From: Griffin, Tim
Sent: 07 October 2022 17:29
To: Harrison, Liz
Cc: Ellison, Mark; Grandfield, Andy; Oliveira, Marta
Subject: Re: F/22/93194 THE AGEAS BOWL, MARSHALL DRIVE, WEST END, SOUTHAMPTON
- landscape comments

Landscape Plan Area 1 west (sheet 1 of 6)

Landscape Plan Area 1 east (sheet 2 of 6)

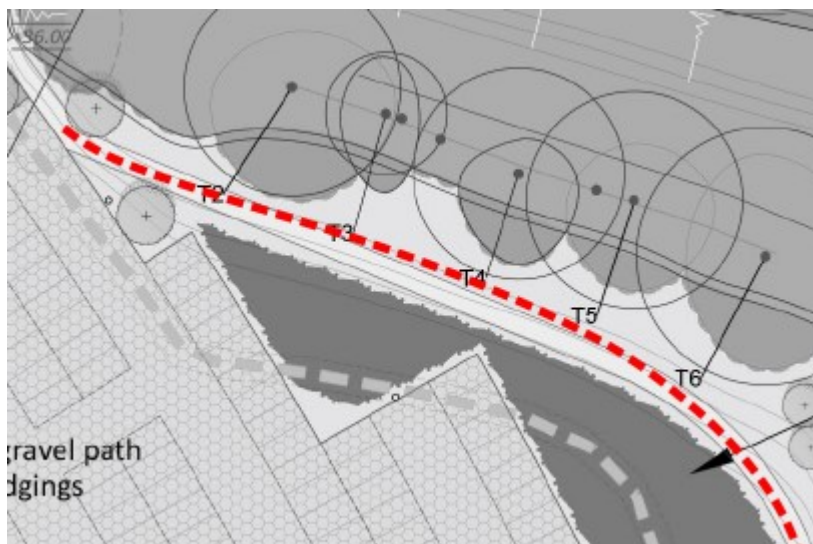
a/ This area lies within the Gap so special attention is required to ensure the protection and enhancement of the Gap.

b/ Parking zones 2 & 3 are presently devoid of any tree planting. Please include some radial tree planting between bays not only to provide shade to parked vehicles but also to increase Green Infrastructure in the Gap.

c/ Further thought is required regarding the pedestrian route that crosses these parking areas. There is currently insufficient protection for pedestrians using this path which raises safety concerns for fans due to vehicles crossing the path to access parking spaces. This path should be tree lined to create an attractive arrivals avenue and I support the idea that a sculpture is indicated to terminate the main vista down this path into the site.

d/ The triangular pool in front of the hotel seems out of keeping with the form of the adjacent lakes that have a more natural profile/shape. Perhaps this pool should have a less geometric shape with a more natural character? As mentioned before, the other option is to omit this lake and use the space to create a focal landscaped space, including planting to soften the area?

e/ Can the route of the diverted PROW be adjusted as below to avoid a pinch-point in the planting? The revised route should be outside RPA's. This would allow an increase in native tree & shrub planting to improve the setting of the path.

Landscape Plan Area 5 West (sheet 5 of 6)

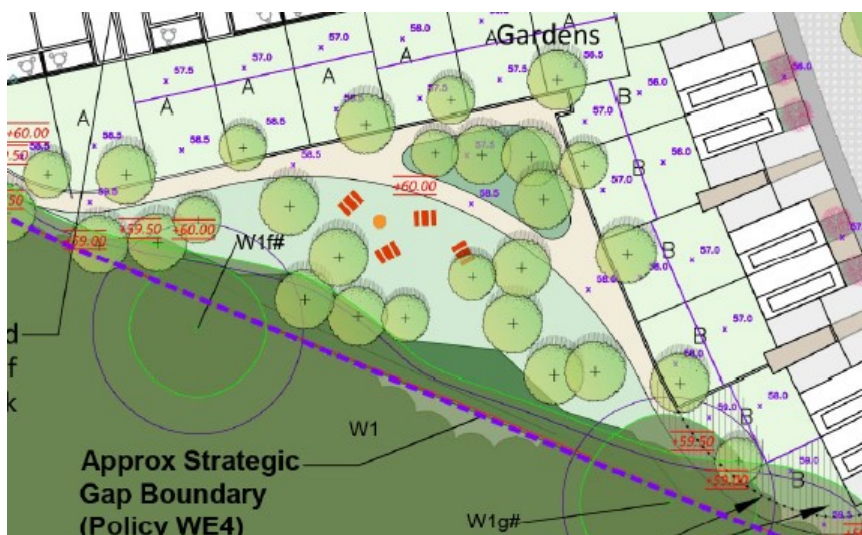
(note: Please add plot numbers to plan)

a/ This is the area of housing and in my view (as stated under general comments above) the density of development is too high. This results in the external realm being dominated by drives, parking and pedestrian circulation leaving limited areas for robust, deliverable Green Infrastructure (GI). In places the roads and paths come very close to the boundaries, a particular concern adjacent to Telegraph Woods. Opportunities for new native planting to protect and bolster the edge along the Woods are few and a wider buffer strip would be preferred.

b/ Street tree planting is a primary aspiration and with the layout being squeezed there are definitely concerns that the tree planting indicated cannot be delivered. In too many locations the space along frontages is very limited with new trees far too close to houses. In some locations trees are shown less than 2m from buildings. This would prevent even a small tree being planted. The layout needs to be re-visited to create realistic space for street tree planting. Please ensure that the tree planting will not be adversely affected by utilities or lighting columns as we will not accept omissions further down the line due to on-site conflicts. All tree planting shown on planning drawings must be deliverable.

c/ I am not clear what is meant by 'walled gardens' and the concept behind this proposal? Tree planting in rear gardens is welcomed but cannot be relied on to provide long-term GI as it can easily be removed by future residents. Is there some way of providing legal protection to ensure the long-term retention of these trees?

d/ There is limited usable amenity space on site and the area below is enclosed by rear gardens and woodland and due to lack of surveillance is not acceptable:

How will access into open spaces by match day fans be controlled? At the moment there seems to be unfettered access for fans across the residential areas?

e/ The proposed number of units in the blocks of apartments necessitates significant numbers of parking bays that erode the area of open space between the apartments and the stadium. This is regrettable and it would be good to see a reduction in parking spaces and a subsequent increase in open space.

All parking areas should be provided with tree planting (1 tree per 4 spaces).

f/ Levels present a challenge in some areas and a number of cross-sections should be provided to help understand the proposals and to assess possible adverse impacts. Some sections are required across the linear open space between the apartments and the stadium so we can assess the feasibility of proposals here, especially the balancing basins.

Please indicate on plan all retaining walls. Wherever possible retaining walls should be below 600mm high to avoid the need for safety railings which add visual clutter to the scene.

g/ Some tree and hedge/shrub planting is required in this area to soften the streetscene:

h/ There is scope to utilise clipped hedges within the core of the site to define defensible space and improve streetscenes and further native mix buffer planting is required around the boundaries to bolster screening.
